The Landings, Ford Airfield

Waste Infrastructure Technical Note

IRM_09.A
December 2024

Report Ref: 2205771-R26

Figure 2: Noise levels due to Operations at the Grundon Site (Application Reference: WSCC/096/13/F and WSCC/027/18/F)

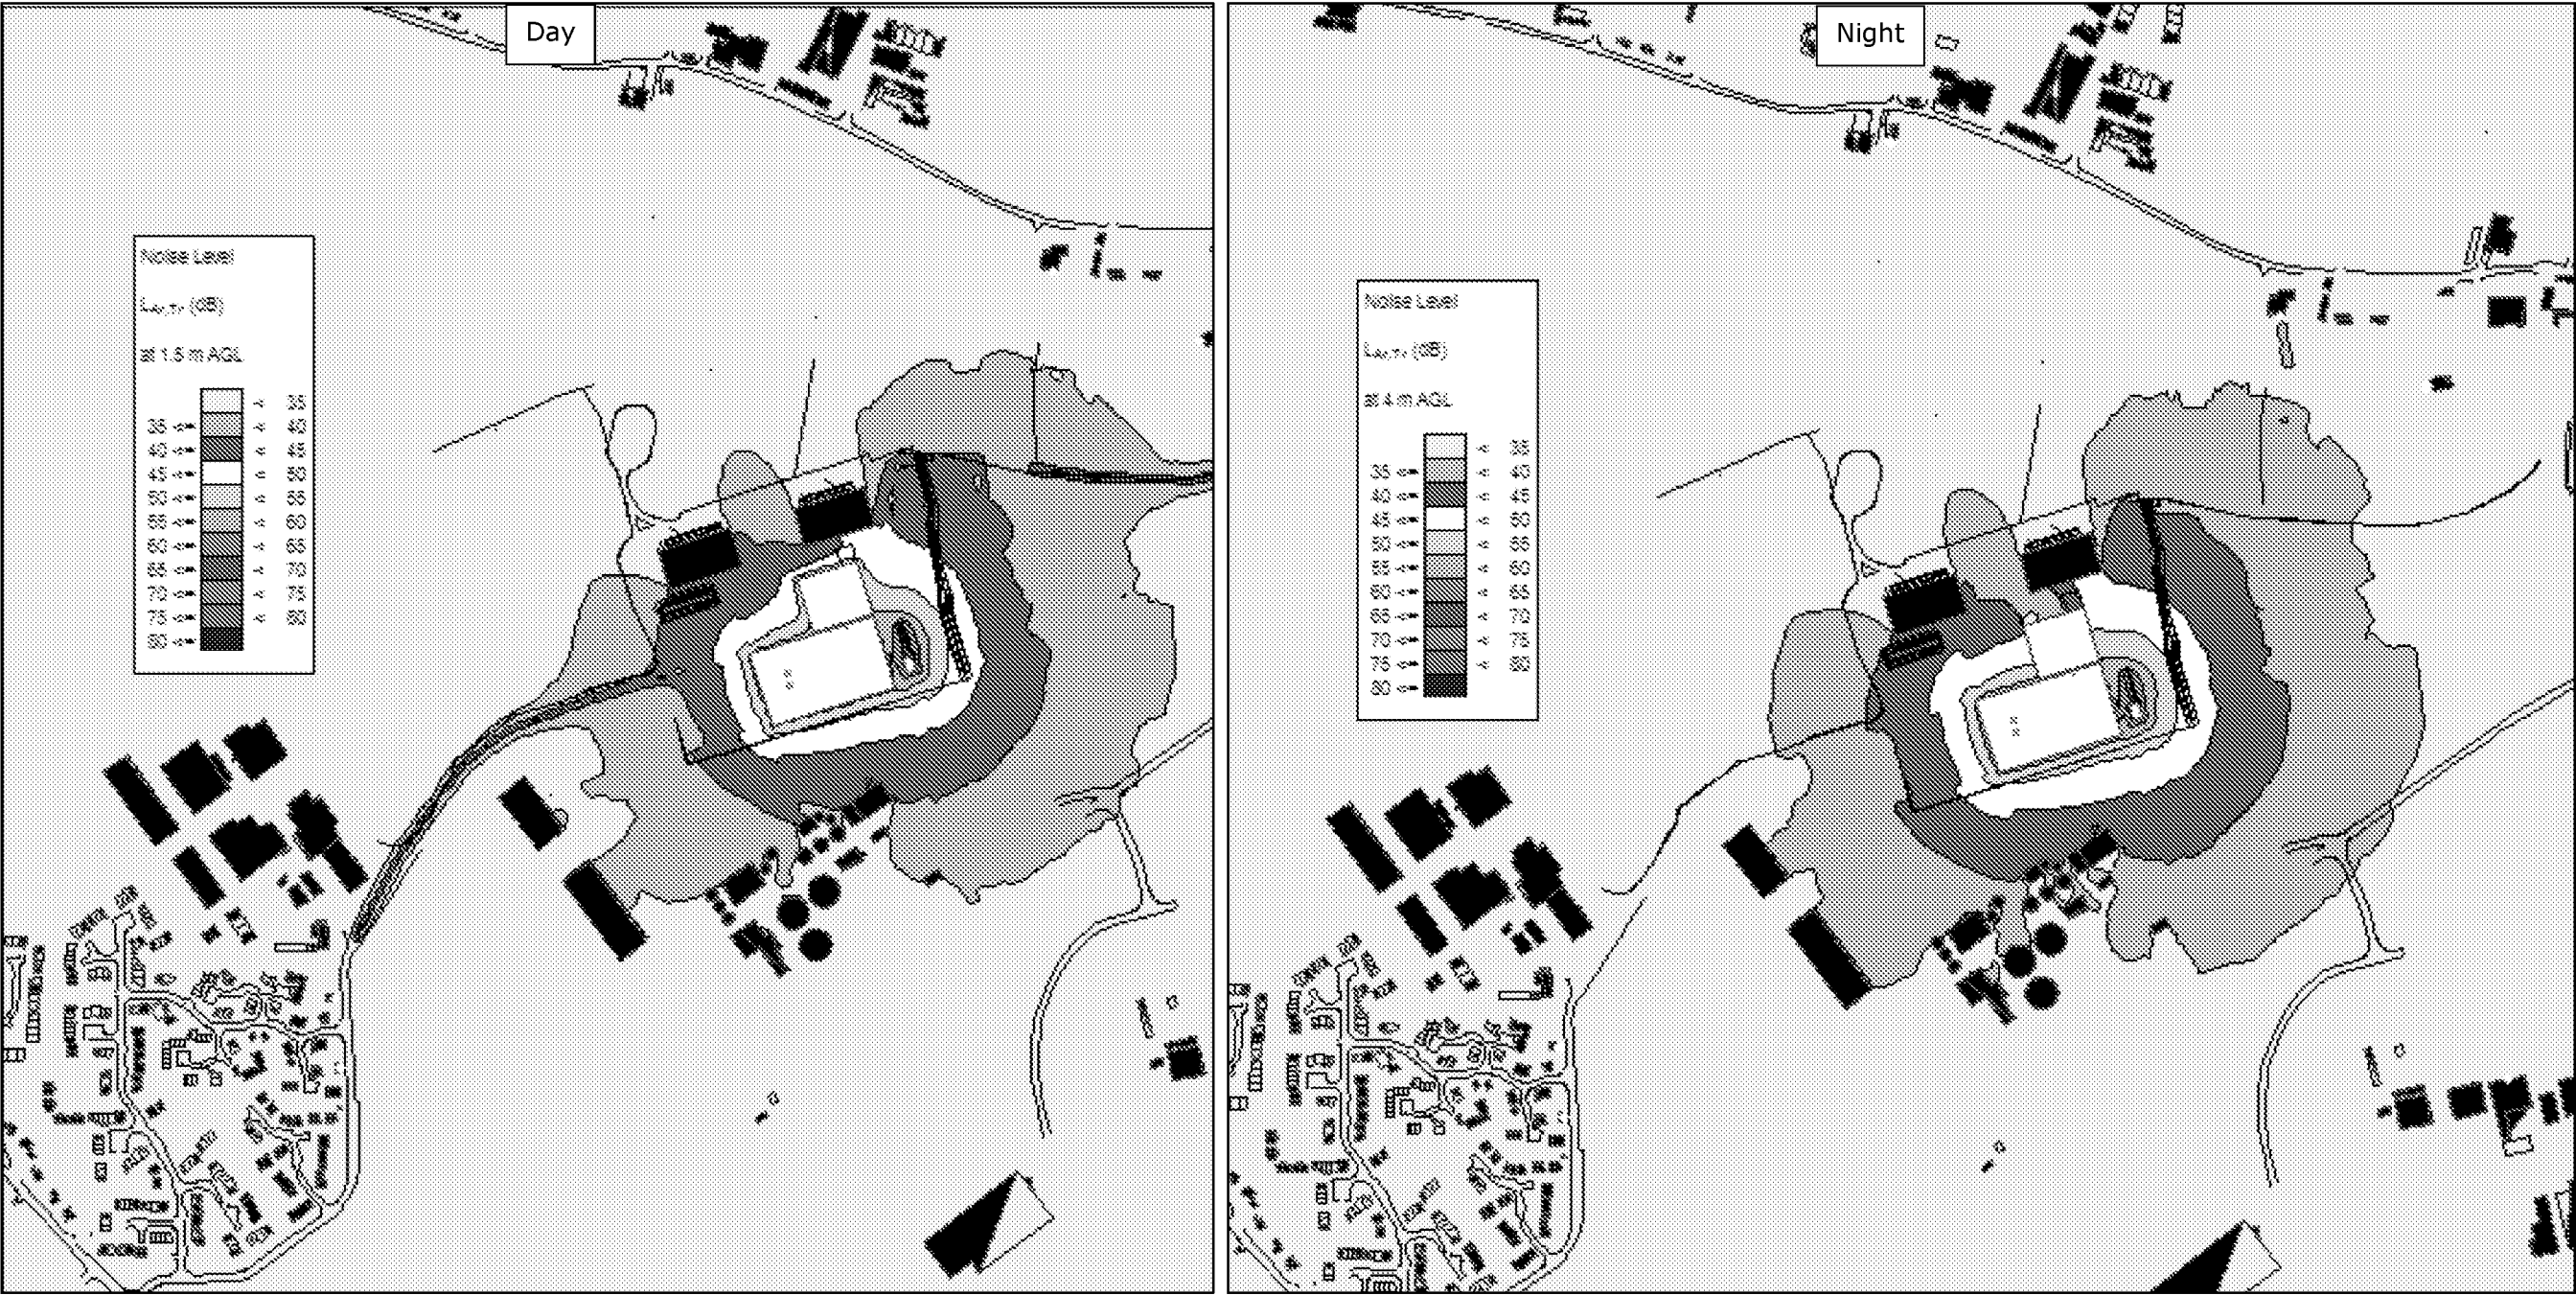
- 2.5. WSCC noted that the noise assessment does not demonstrate that noise from the Circular Technology Park/Grundon Waste Facility (Grundon) will meet the requirements of Condition 28 of the planning application for the facility, i.e., a rating level no greater than 35dB at the nearest sensitive receptors.

- WSCC/096/13/F: Circular Technology Park;
 - WSCC/027/18/F: Circular Technology Park;
 - WSCC/026/16/F: Wicks Farm;
 - WSCC/019/17/F: Wicks Farm;
- 2.7. The comments also note that noise levels from HD White (Ford Industrial Estate) would exceed the requirements of Condition 7, i.e. a rating level at the nearest sensitive receptors no greater than 5dB below the representative background sound level.

- 2.12. The noise assessment which accompanied the planning application for the Grundon Site shows the modelled noise levels with the proposed future operations, an extract from the noise modelling is shown below in Figure 2. Based on the noise modelling, noise levels are predicted to be significantly below 35dB $L_{A_r,Tr}$ at RM1 (North).

Figure 6: Proposed 4m High Noise Barrier Locations and Landscaping

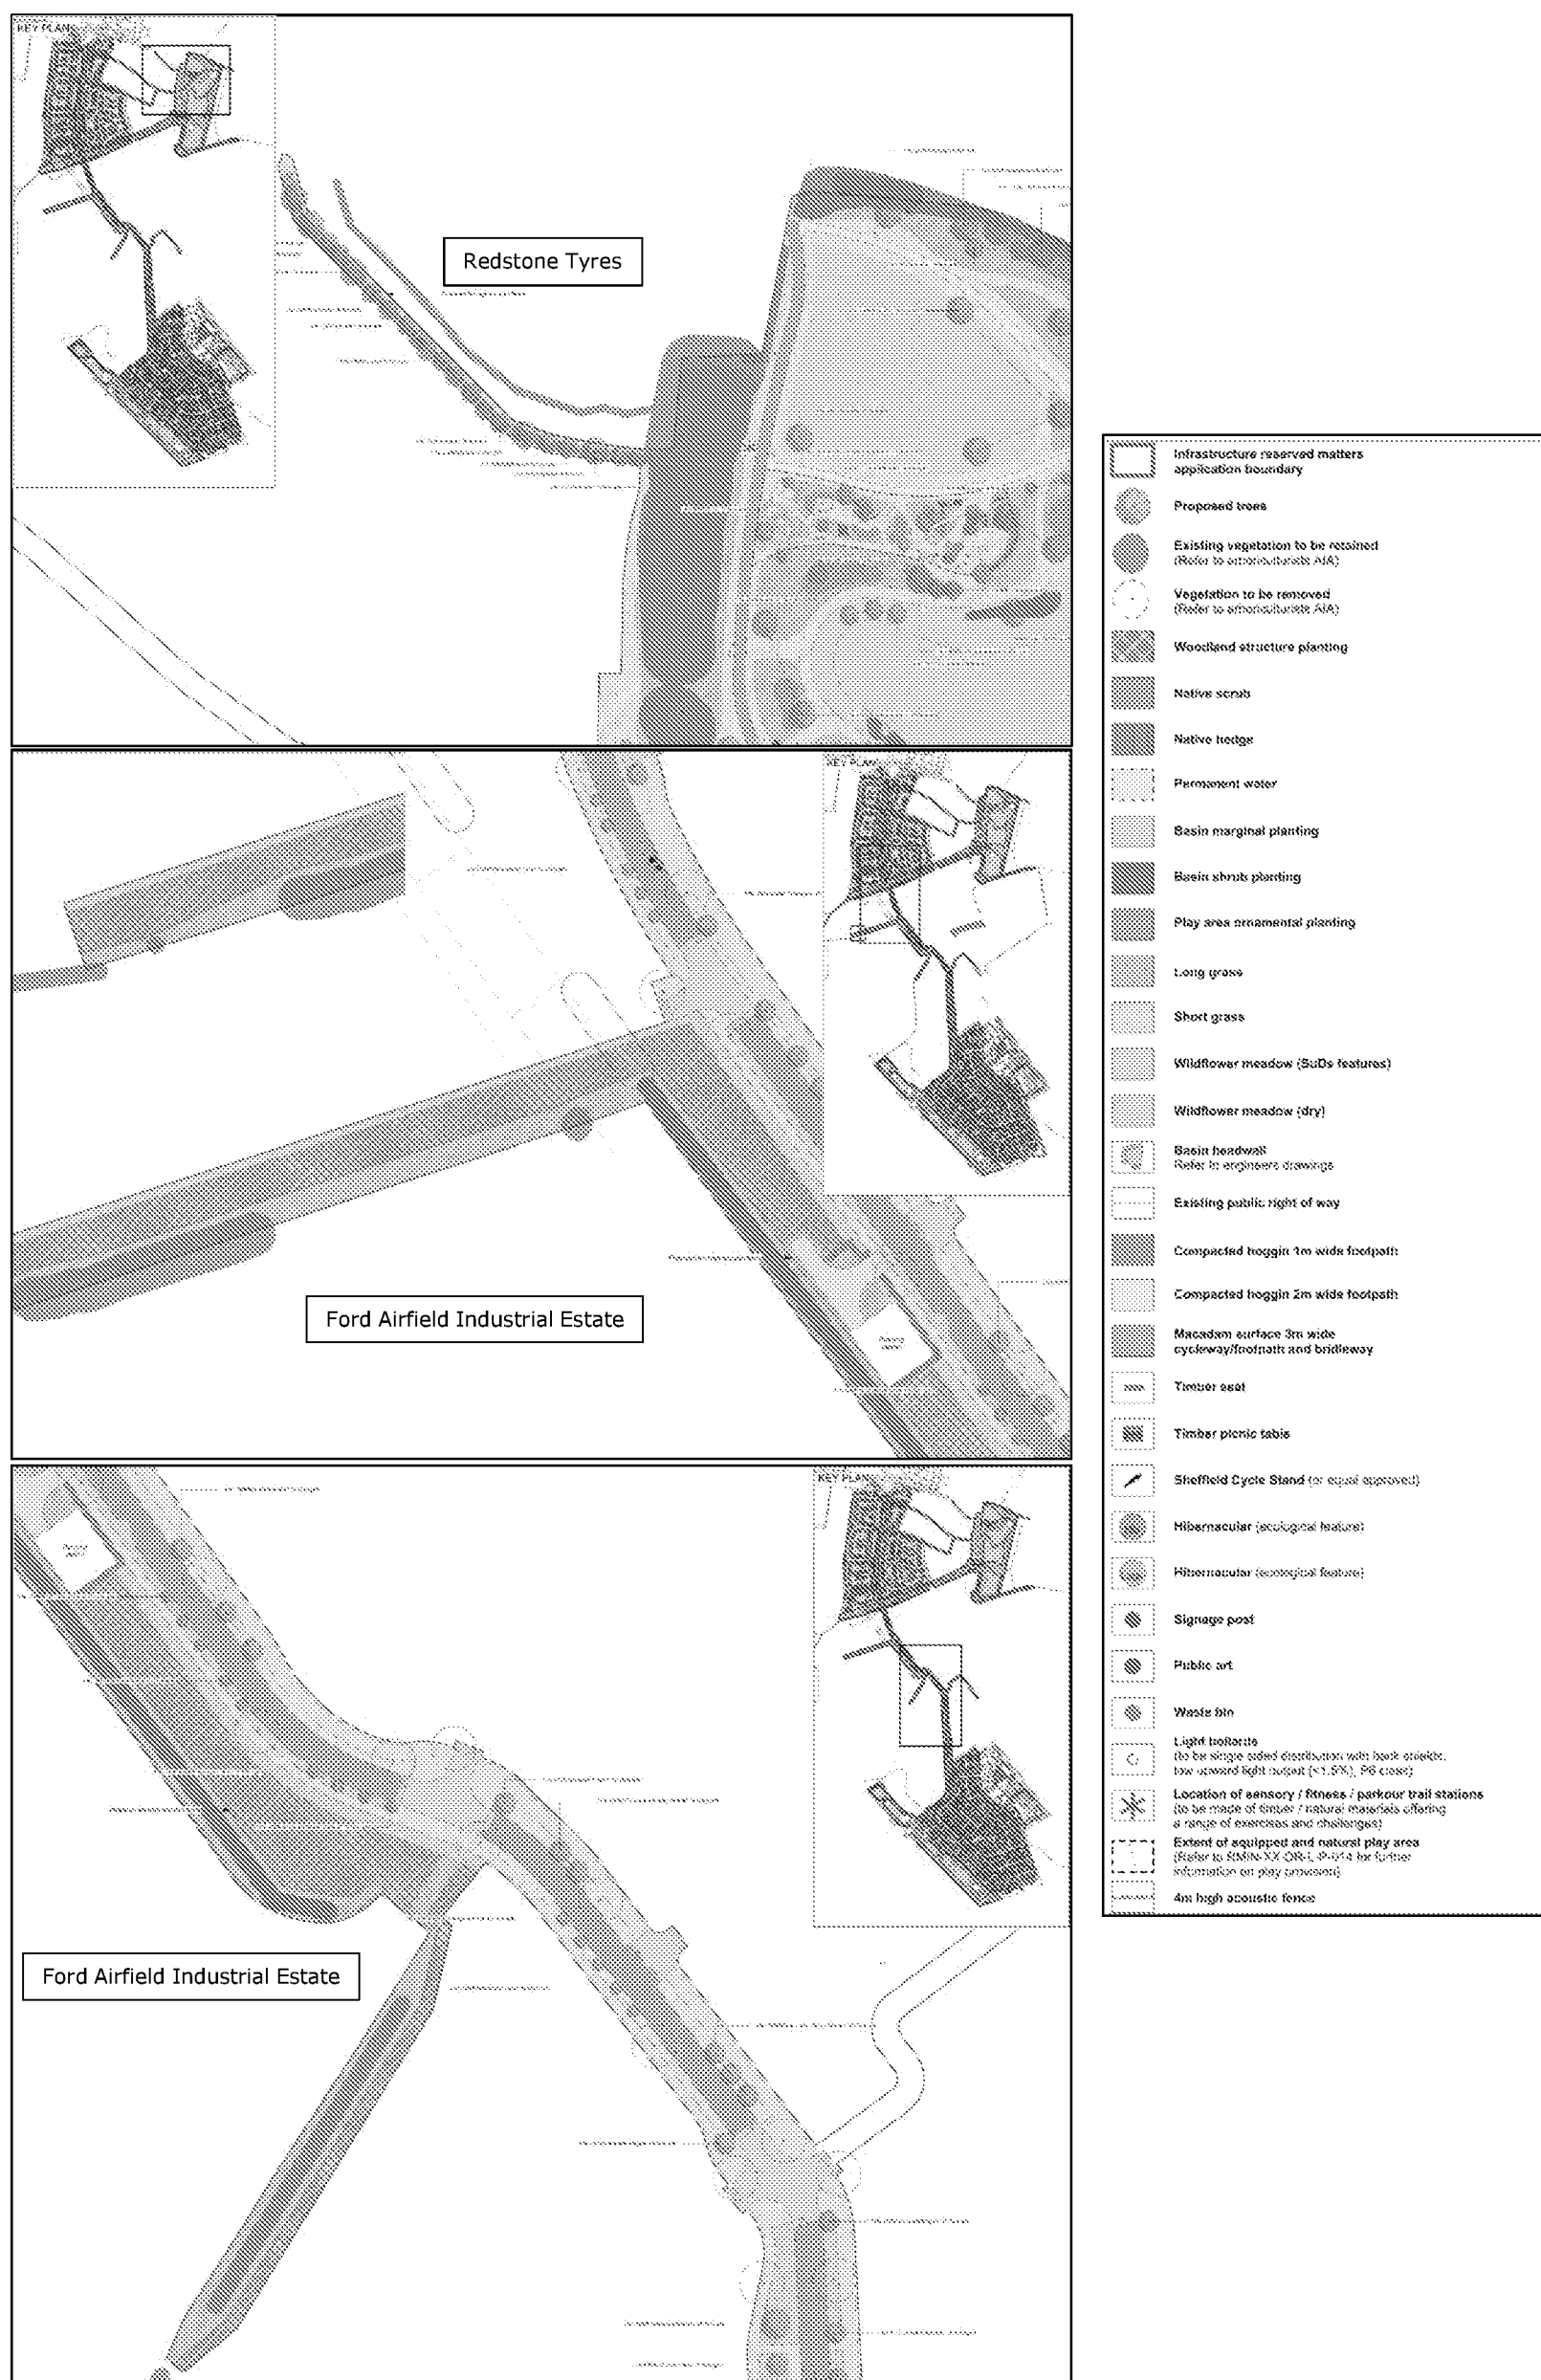
- 3.1. Officers at ADC have provided comments in relation to the infrastructure and RM1 (North) Reserved Matters planning applications.
- 3.2. The comments regarding the infrastructure Reserved Matters planning application noted that further details of the noise mitigation measures to provide suitable internal and external amenity sound levels at the site needed to be provided to support the discharge of Condition 25.

- 4.4. The locations of the 4m high noise barriers are shown in the primary street drawings which accompany the infrastructure Reserved Matters planning application. Structural woodland planting, basin shrub planting and trees are proposed, which will reduce the visual impact of the barriers. An extract of the drawings is shown in Figure 6.

- 4.5. A number of heights have been tested and the results of the noise modelling identify that a barrier height of 4m provides the best possible reduction in noise levels, whilst also taking into account other design considerations, such as landscaping and arboriculture. Taller structures would provide little additional acoustic benefit and would have an increased visual impact.
- 4.6. The results of the noise modelling with the proposed barriers is presented in Figure 7. The noise modelling presents noise from the Ford Airfield Industrial Estate and Redstone Tyres in isolation, to demonstrate the reduction in noise levels achieved by the noise barriers in relation to these operations.
